## Baseline for Figure 33-14 update to Type 3 and Type 4, v233

**Replace Figure 33-14, Equation 33-6 and Equation 33-7 by:**

Figure 33-14—Type 1 or Type 2 PSE POWER\_ON state PI operating current templates

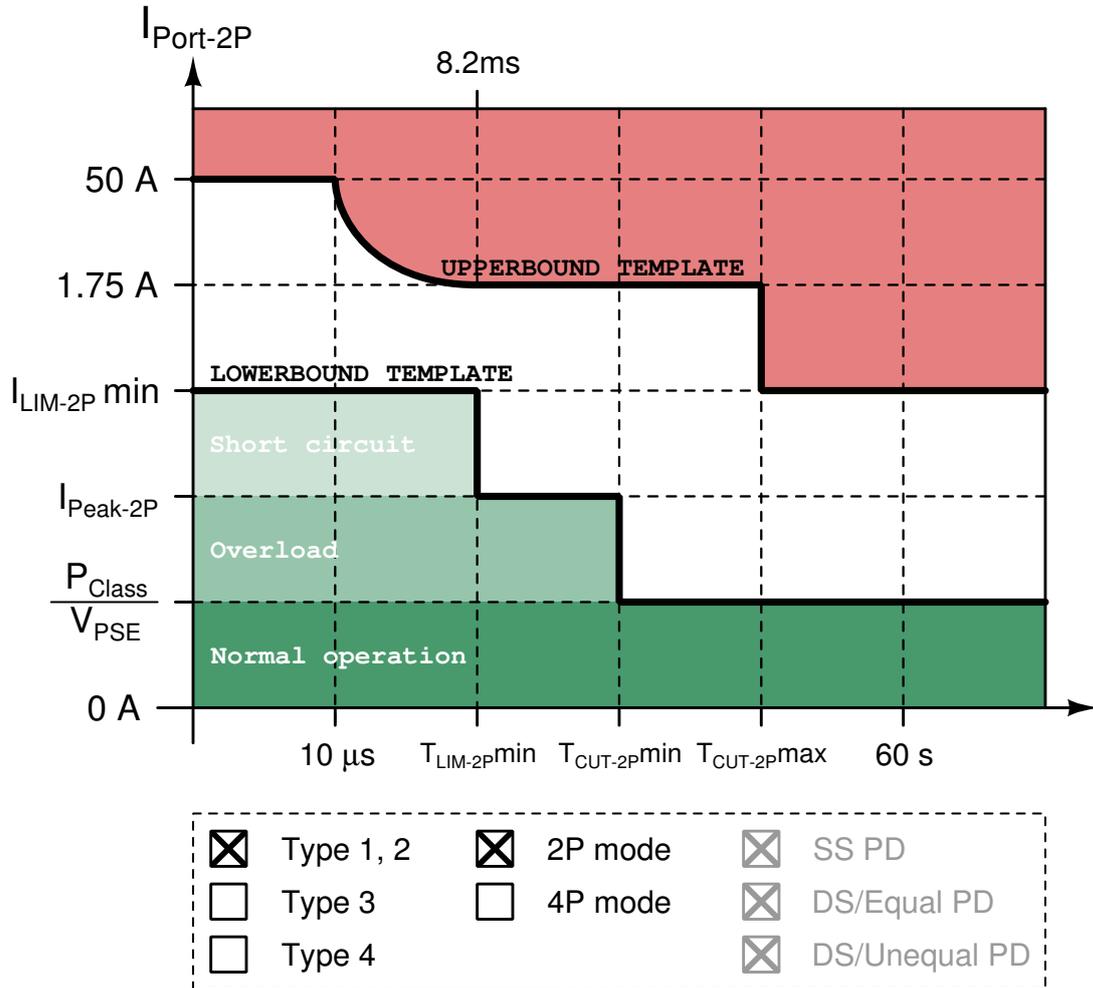
- Equation 33-6, Equation 33-7 and Figure 33-14 apply to Type 1 and Type 2 PSEs.
- Equation 33-6a, Equation 33-7a and Figure 33-14a apply to Type 3 and Type 4 PSEs that operate in 2-pair mode, as well as to Type 3 and Type 4 PSEs operating in 4-pair mode, connected to a Dual-signature PD that advertised a different class signature on each pairset.

$$I_{\text{PSEUT-2P}}(t) = \left. \begin{cases} 50 & \text{for } (0 \leq t < 10.0 \times 10^{-6}) \\ \sqrt{\frac{K}{t}} & \text{for } (10.0 \times 10^{-6} \leq t < 8.20 \times 10^{-3}) \\ 1.75 & \text{for } (8.20 \times 10^{-3} \leq t < T_{\text{CUT-2P max}}) \\ I_{\text{LIM-2P min}} & \text{for } (T_{\text{CUT-2P max}} \leq t) \end{cases} \right\}_A \quad (33-6)$$

$$I_{\text{PSELT-2P}}(t) = \left. \begin{cases} I_{\text{LIM-2P min}} & \text{for } (0 \leq t < T_{\text{LIM-2P min}}) \\ I_{\text{Peak-2P}} & \text{for } (T_{\text{LIM-2P min}} \leq t < T_{\text{CUT-2P min}}) \\ \frac{P_{\text{Class}}}{V_{\text{PSE}}} & \text{for } (T_{\text{CUT-2P min}} \leq t) \end{cases} \right\}_A \quad (33-7)$$

Figure 33-14a—Type 3 or Type 4 PSE POWER.ON state PI operating current templates when connected to a Dual-signature PD with different class code on each pairset

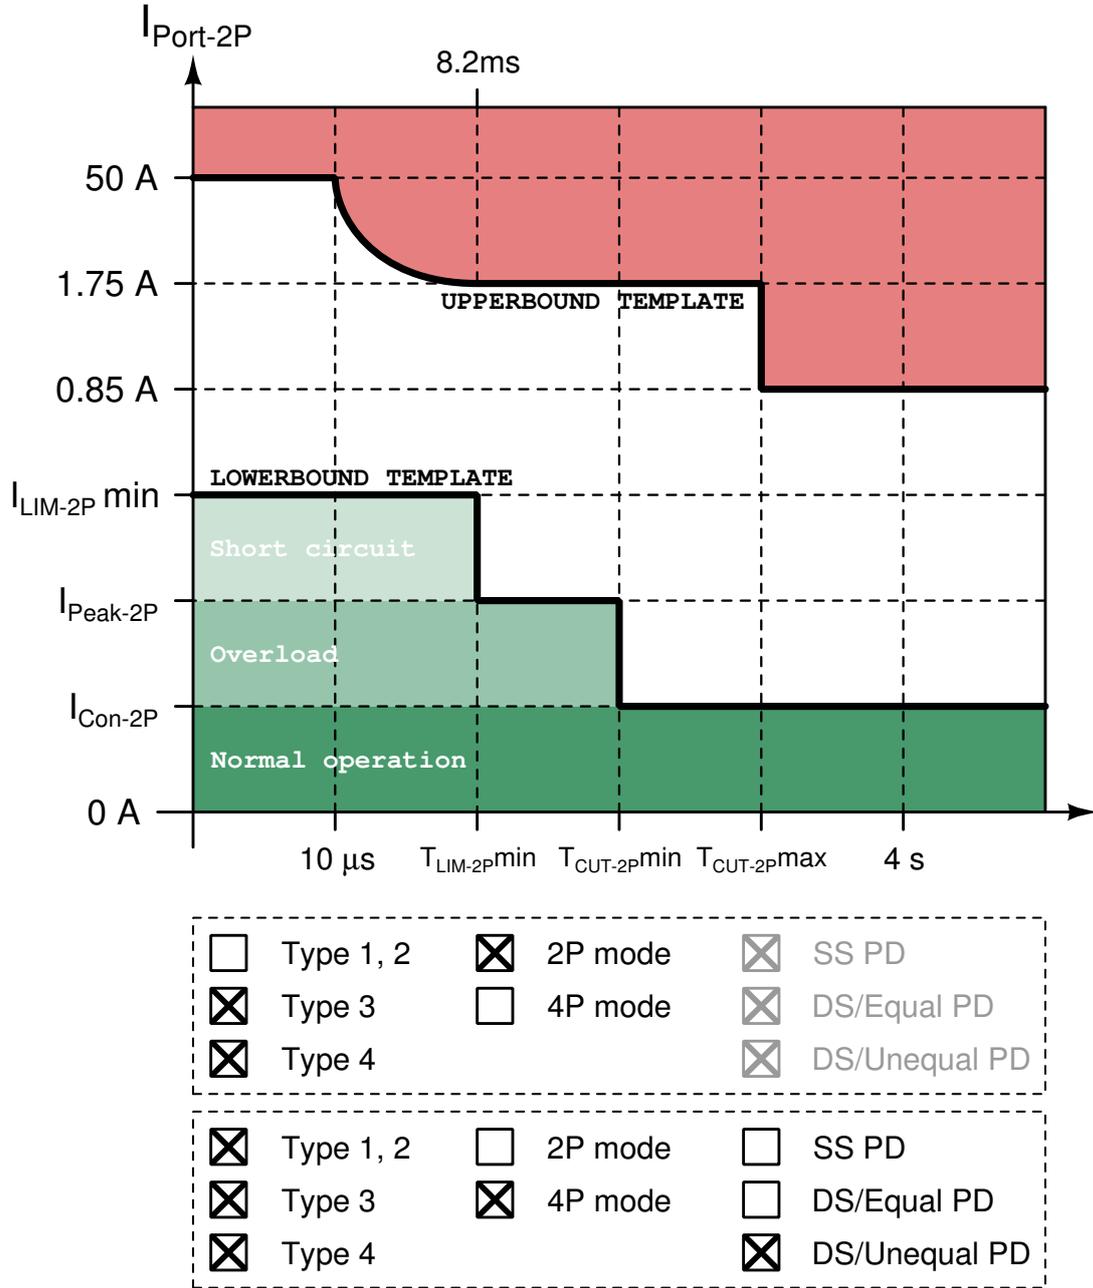
The fixed current limit of 0.85A in the upperbound template is introduced to allow a PSE to set an  $I_{CUT}$  limit that is Type-fixed and does not need to change with Class. We are limited by LPS (Limited Power Source, IEC60950) requirements (source  $\leq 100W$ ) therefore the maximum continuous current per pairset allowed is:

$$\frac{100W}{57V} / 2 = 877mA$$

By choosing 0.85A the maximum allowed sustained power for Type 3 is  $0.85A \times 2 \times 57V = 96.9W$ .

$$I_{\text{PSEUT-2P}}(t) = \left. \begin{cases} 50 & \text{for } (0 \leq t < 10.0 \times 10^{-6}) \\ \sqrt{\frac{K}{t}} & \text{for } (10.0 \times 10^{-6} \leq t < 8.20 \times 10^{-3}) \\ 1.75 & \text{for } (8.20 \times 10^{-3} \leq t < T_{\text{CUT-2P max}}) \\ 0.85 & \text{for } (T_{\text{CUT-2P max}} \leq t) \end{cases} \right\}_A \quad (33-6a)$$

$$I_{\text{PSELT-2P}}(t) = \left. \begin{cases} I_{\text{LIM-2P min}} & \text{for } (0 \leq t < T_{\text{LIM-2P min}}) \\ I_{\text{Peak-2P}} & \text{for } (T_{\text{LIM-2P min}} \leq t < T_{\text{CUT-2P min}}) \\ I_{\text{Con-2P}} & \text{for } (T_{\text{CUT-2P min}} \leq t) \end{cases} \right\}_A \quad (33-7a)$$

Figure 33-14b—Type 3 PSE POWER\_ON state PI operating current templates

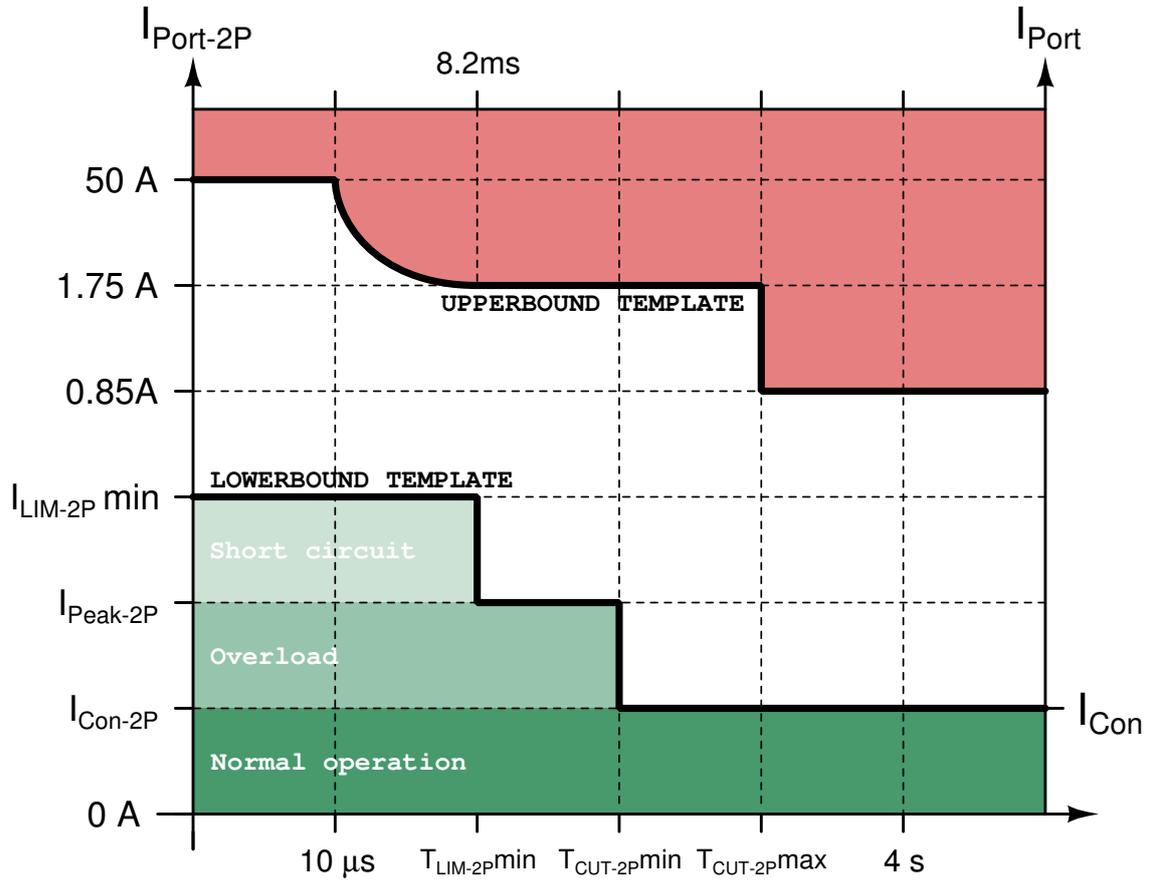
- Equation 33-6b, Equation 33-7b and Figure 33-14b apply to Type 3 PSEs operating in 4-pair mode, connected to a Single-signature PD, or connected to a Dual-signature PD that advertised the same class signature on each pairset.
- Equation 33-6c, Equation 33-7c and Figure 33-14c apply to Type 4 PSEs operating in 4-pair mode, connected to a Single-signature PD, or connected to a Dual-signature PD that advertised the same class signature on each pairset.

$$I_{\text{PSEUT-2P}}(t) = \left. \begin{cases} 50 & \text{for } (0 \leq t < 10.0 \times 10^{-6}) \\ \sqrt{\frac{K}{t}} & \text{for } (10.0 \times 10^{-6} \leq t < 8.20 \times 10^{-3}) \\ 1.75 & \text{for } (8.20 \times 10^{-3} \leq t < T_{\text{CUT-2P max}}) \\ 0.85 & \text{for } (T_{\text{CUT-2P max}} \leq t) \end{cases} \right\}_A \quad (33-6b)$$

$$I_{\text{PSELT-2P}}(t) = \left. \begin{cases} I_{\text{LIM-2P min}} & \text{for } (0 \leq t < T_{\text{LIM-2P min}}) \\ I_{\text{Peak-2P}} & \text{for } (T_{\text{LIM-2P min}} \leq t < T_{\text{CUT-2P min}}) \\ I_{\text{Con-2P}} & \text{for } (T_{\text{CUT-2P min}} \leq t) \end{cases} \right\}_A \quad (33-7b)$$
